DART AEROSPACE LTD		Work Order:	94351
Description: Crosstube Assembly (205/212/412 High Fwd)		Part Number:	D212-664-141
Inspection Dwg: D212-664-141 Rev: D		Page 1 of 2

DRAWING NO. D212-664-141	TITLE XTUBE ASSY (205/212/412 HI FWD)	REV. D	DART AEROSPACE LTD ENGINEERING ORDER		D.E.O. NO. D212-664-141-D-1	SHEET NO. SHEET 1 OF 2	SCALE NTS
DRAWN	CHECKED	OP	MFG. APPR.	R	APPROVED	MP	DE APPR.
DATE 11.04.07	DATE 11.07.11		DATE 11.04.12		DATE 11/04/12		DATE 11.04.12

ADD AN INSPECTION WINDOW TO UNDERSIDE OF CROSSTUBE.

REPLACE MAGNOBOND WITH PROSEAL.

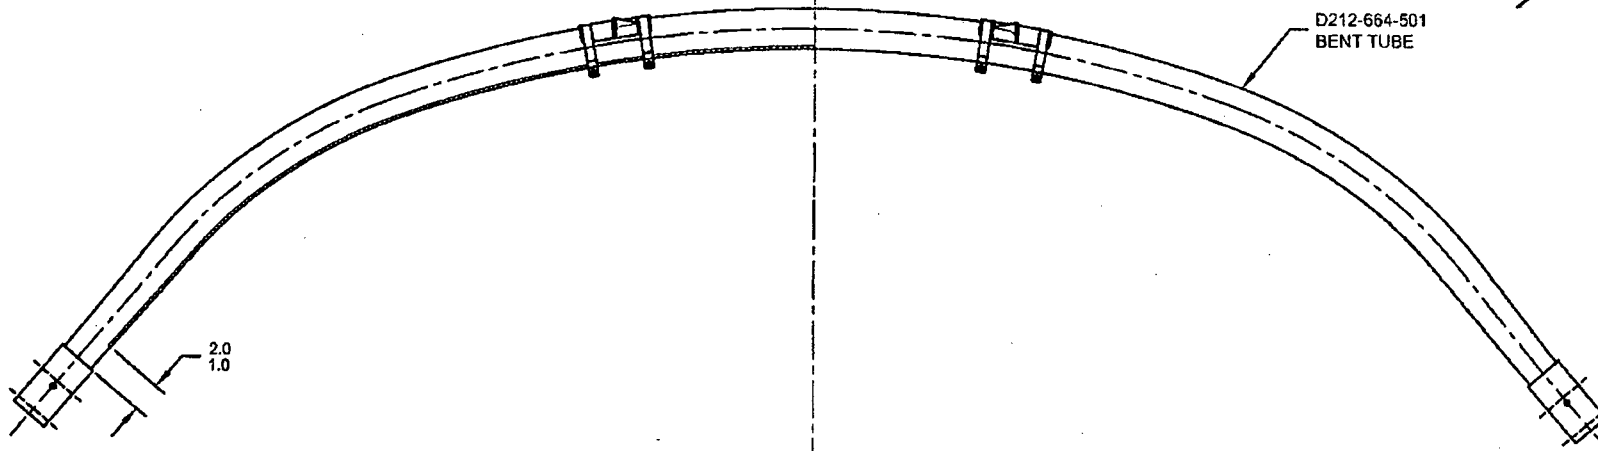
NOTES 2 OF SHEET 1 IS AMENDED AS FOLLOWS:

- 2) FINISH: CHEMICAL CONVERSION COAT PER DART QSI 005 4.1
PRIME INSIDE AND OUTSIDE PER DART QSI 005 4.2
MASK UNDERSIDE OF CROSSTUBE AS SHOWN (HATCHED AREA) AND
PAINT OUTSIDE PER DART QSI 005 4.2
REMOVE MASKING AND APPLY CLEAR COAT

- 2) FINISH: CHEMICAL CONVERSION COAT PER DART QSI 005 4.1
PRIME INSIDE AND OUTSIDE PER DART QSI 005 4.2
PAINT OUTSIDE PER DART QSI 005 4.2

MASK AREA PRIOR TO PAINTING.
REMOVE MASKING AFTER PAINT
AND APPLY CLEAR COAT
